Access Compliance Report

Public Rights-of-Way

(Curb Ramps)

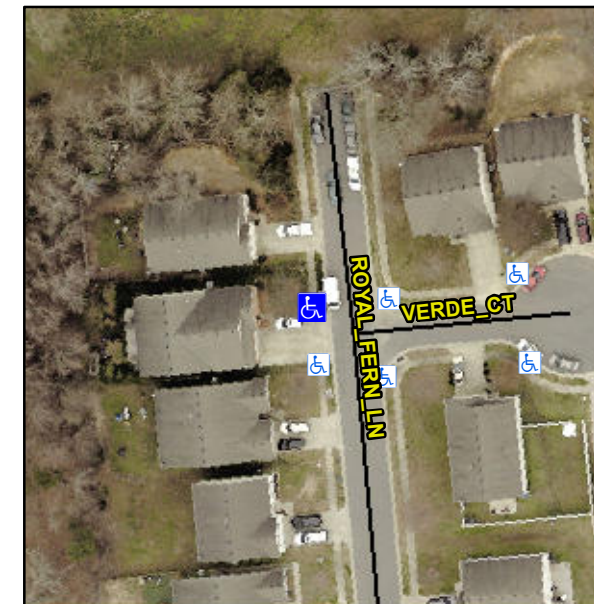
Intersection ID: 47821	Main Street: VERDE_CT	Cross Street: ROYAL_FERN_LN	Location: NW
ADA ID: C08B140268DC	Ramp Type: Perp	Initial Pass/Fail: Fail	Overall Compliance: No
		Severity Score: 8.75	
Codes/Mitigation Info/Possible Solution		Field Measurements/Component Compliance

Not Found, R304.5.1

Compliance	Description	Data	Compliance	Description	Data
N/A	Ramp Length (in)	48.0	Yes	Ramp Slope (%)	6.3
No	Ramp Width (in)	47.5	Yes	Ramp XSlope (%)	1.5
N/A	Flare Type LT	N/A	N/A	Flare Type RT	N/A
N/A	Flare Slope LT (%)	N/A	N/A	Flare Slope RT (%)	N/A
N/A	Flare Traversable LT?	N/A	N/A	Flare Traversable RT?	N/A
N/A	Landing Length (in)	N/A	N/A	DWS Provided?	N/A
N/A	Landing Width (in)	N/A	N/A	DWS Contrast?	N/A
N/A	Landing Slope (%)	N/A	N/A	DWS Length (in)	N/A
N/A	Landing X Slope (%)	N/A	N/A	DWS Full Width?	N/A
N/A	Landing Curb? (Y/N)	N/A	N/A	DWS Offset (in)	N/A
N/A	Shared Landing?	N/A			
N/A	Gutter Ponding?	N/A	N/A	Gutter Slope (%)	N/A
N/A	Gutter Lip Ht (in)	N/A	N/A	Gutter X Slope (%)	N/A
N/A	Painted X Walk1?	No	N/A	Painted X Walk2?	N/A
	X Walk 1 Direction	To E		X Walk 2 Direction	N/A
N/A	X Walk 1 Width (in)	N/A	N/A	X Walk 2 Width (in)	N/A
	X Walk 1 Slope (%)	3.1		X Walk 2 Slope (%)	N/A
	X Walk 1 X Slope (%)	1.1		X Walk 2 X Slope (%)	N/A

Remove & Replace Entire Ramp.
